# San Francisco Bay Conservation and Development Commission

**SUBJECT: DRB Comment Letters**

ALBANY BEACH RESTORATION  
 AND PUBLIC ACCESS PROJECT  
 MULTI-USER-GENERATED CONCEPT PLAN  
 WITH EXPANDED BEACH + WETLANDS

Enc: Exhibit A: Parking lot or Beach

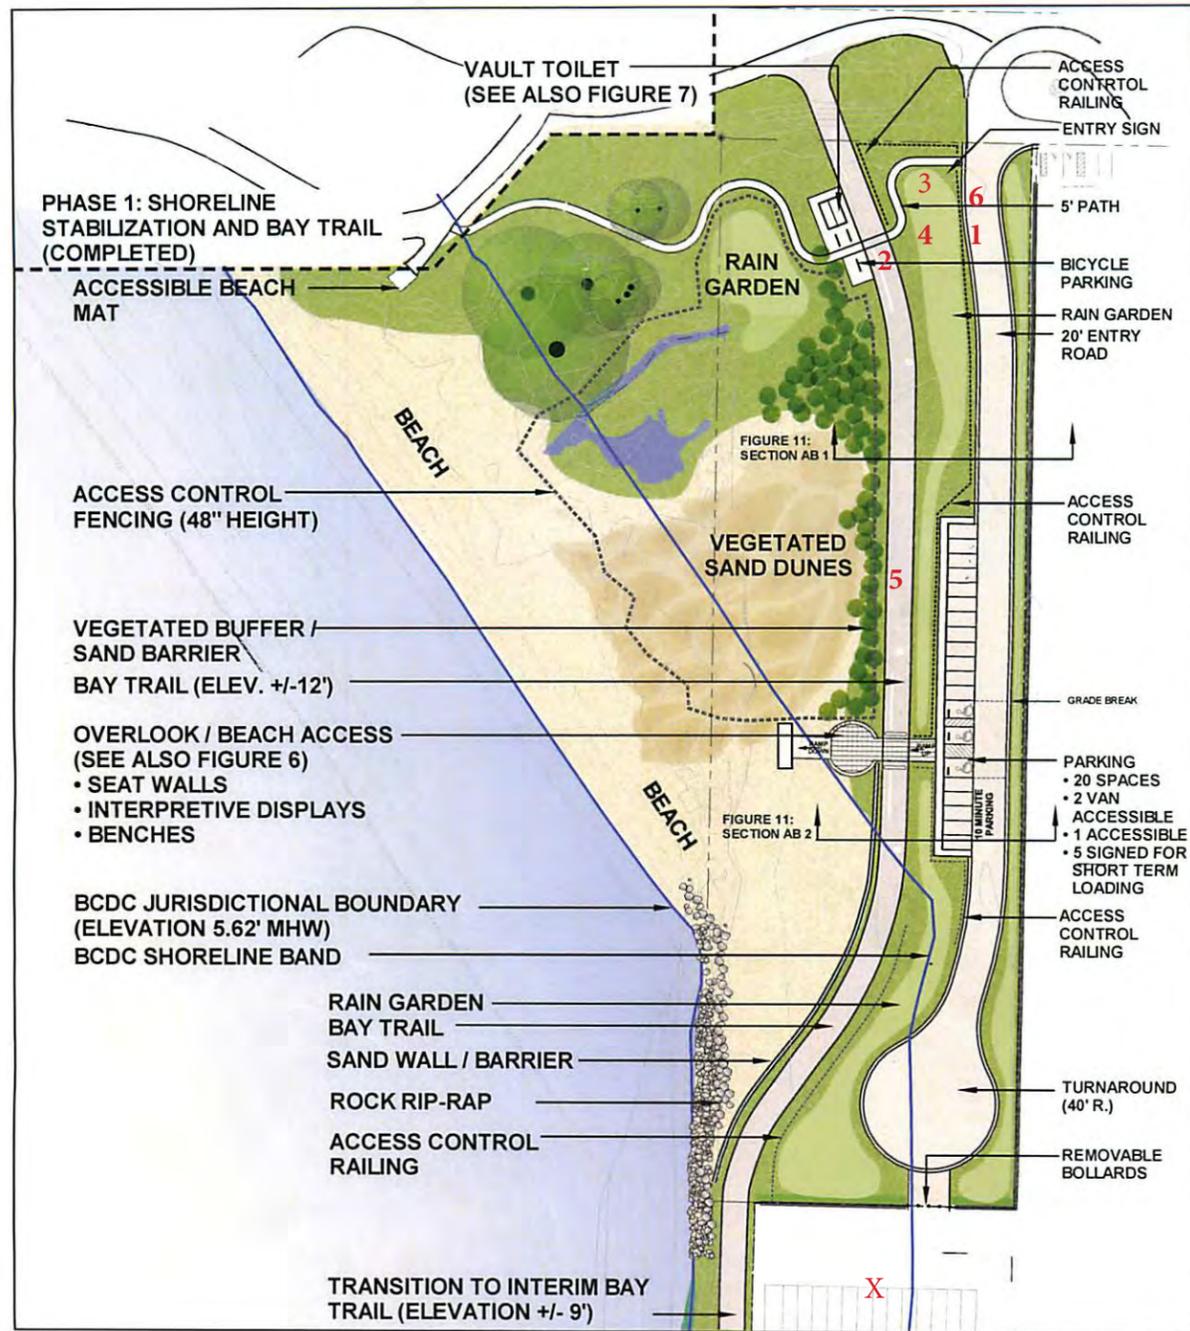
The parking lot wants to be a beach, not a parking lot. There will be a constant battle against sand in the proposed plan.

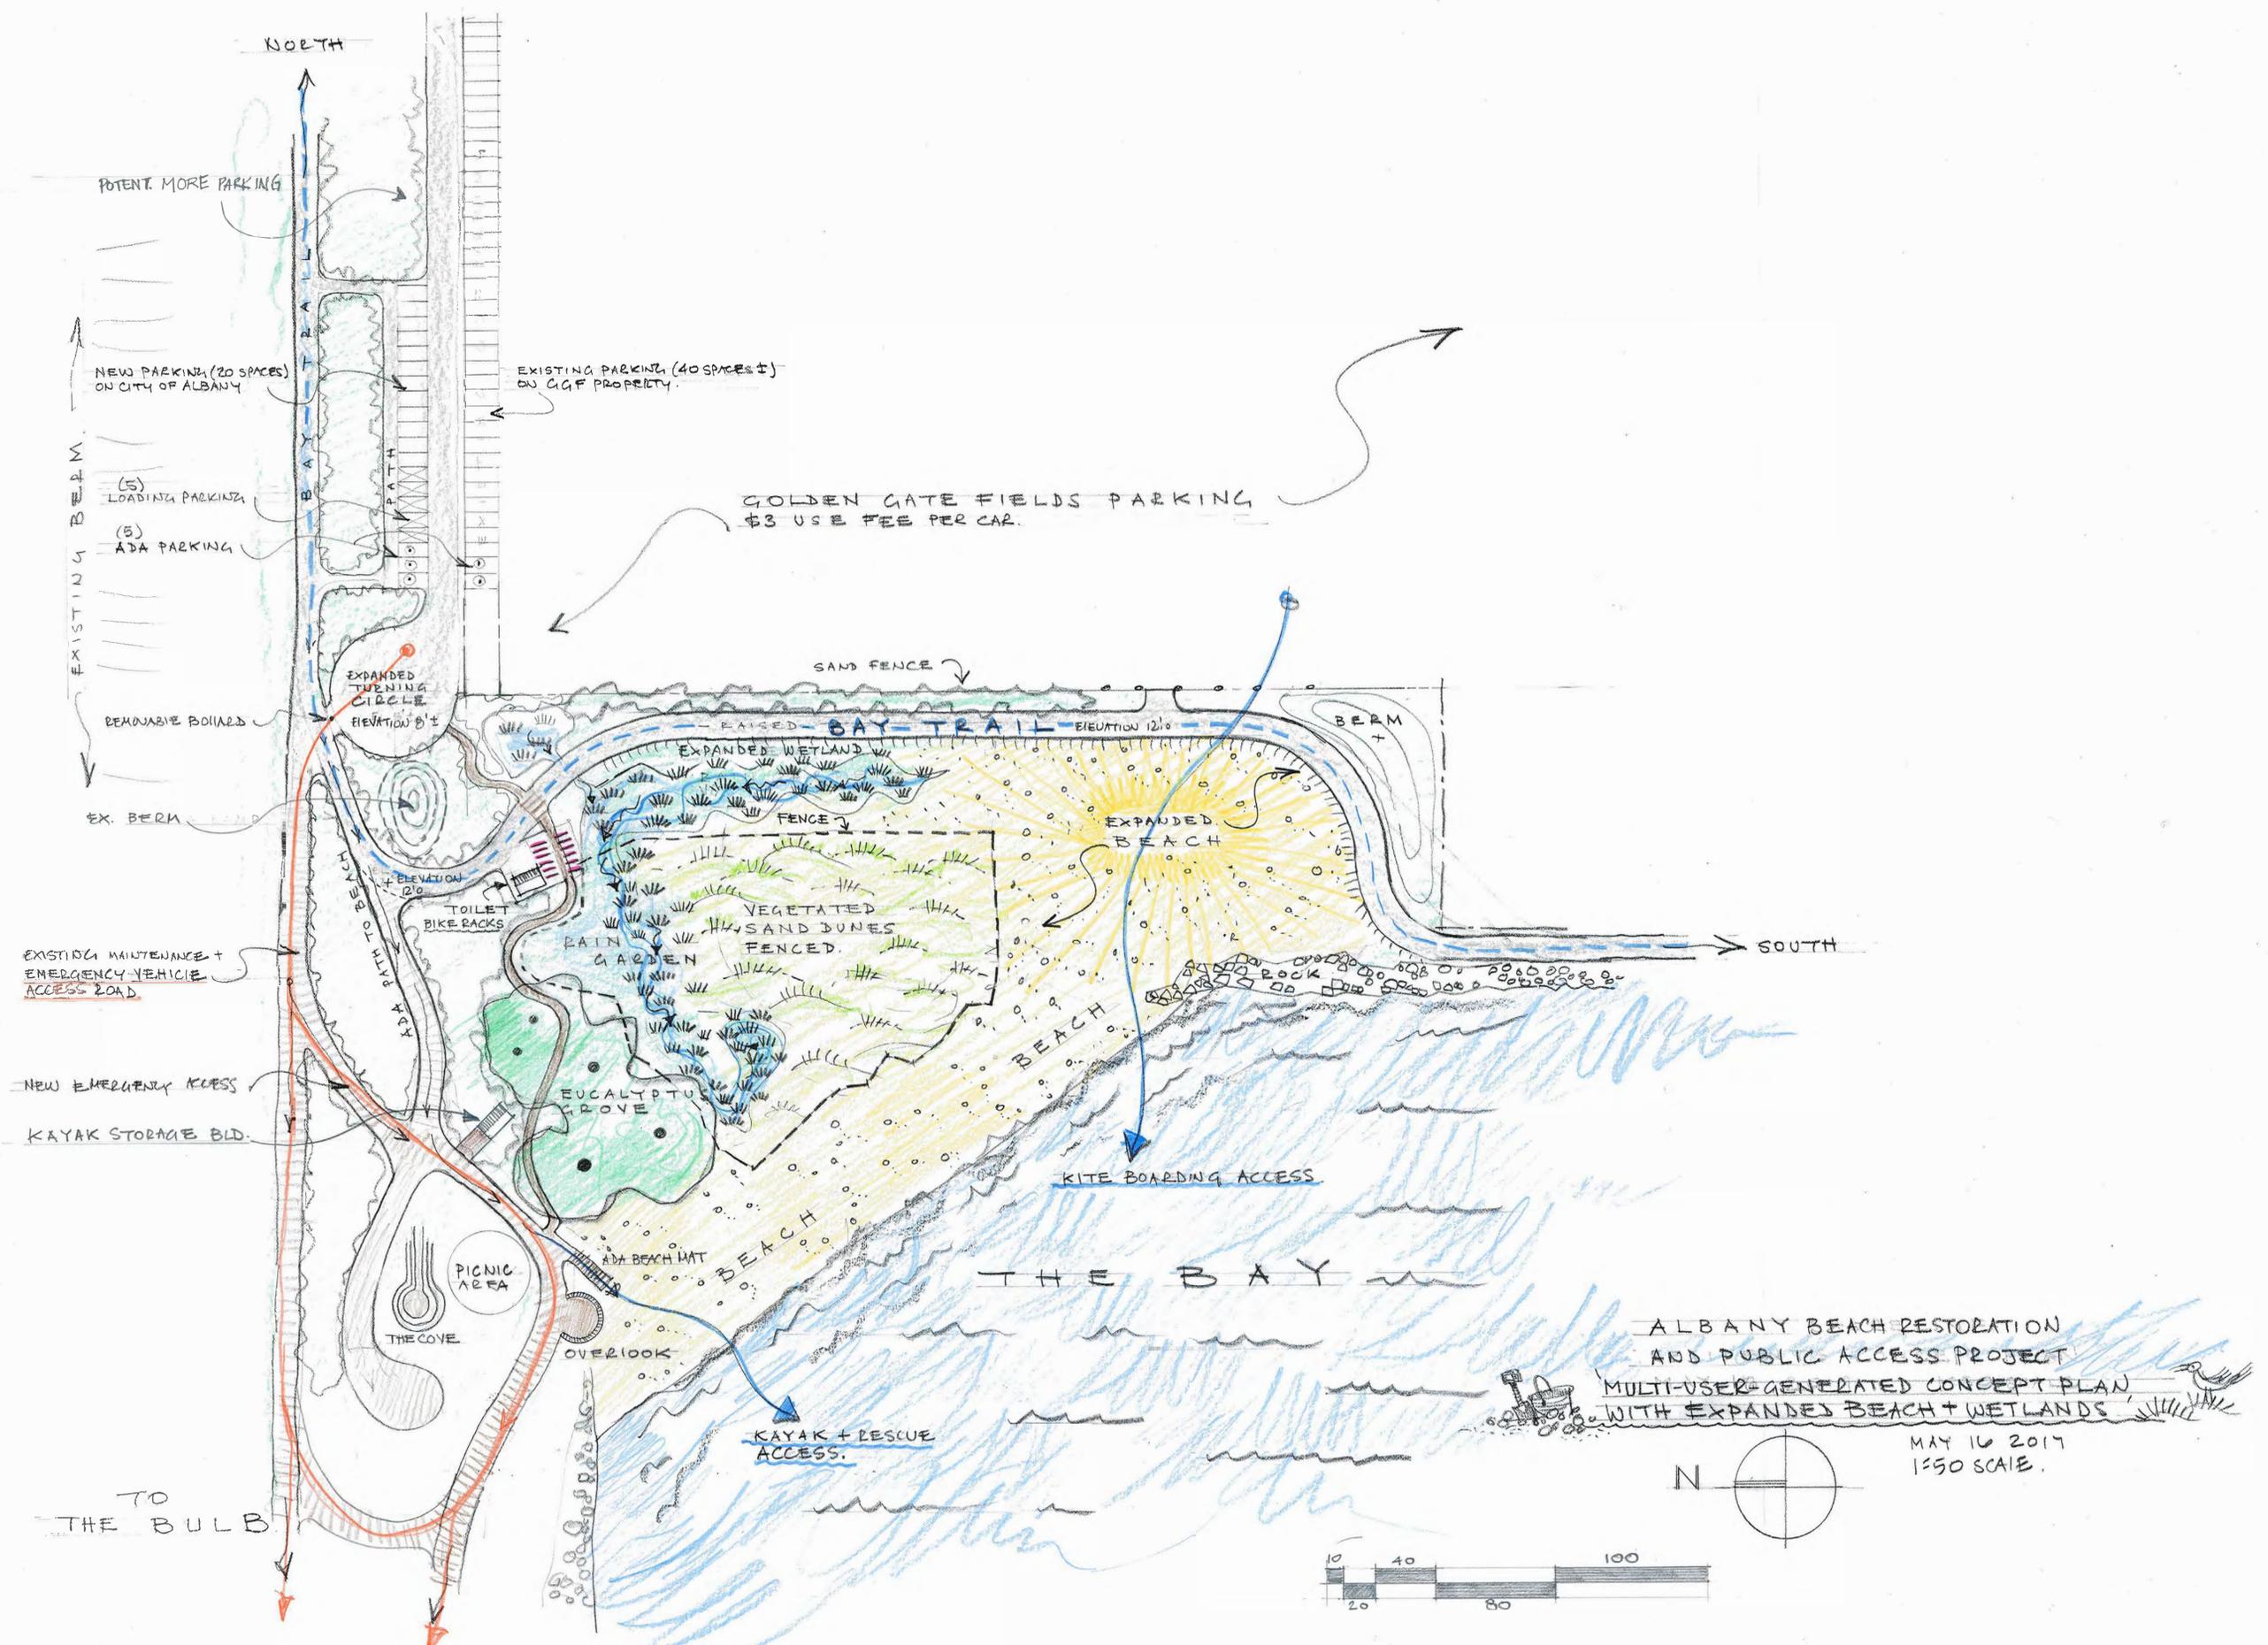
2. This is looking northeast toward the bird sculpture and existing turnaround (behind gate).

3. Looking southwest across parking lot from near green gate shown in #2

4. The sand on the parking lot is several inches deep

5. Looking south. The sand accumulates even to the south of the project site. This sandstorm (kicked up up by a truck) is located south of the X marked in the diagram.
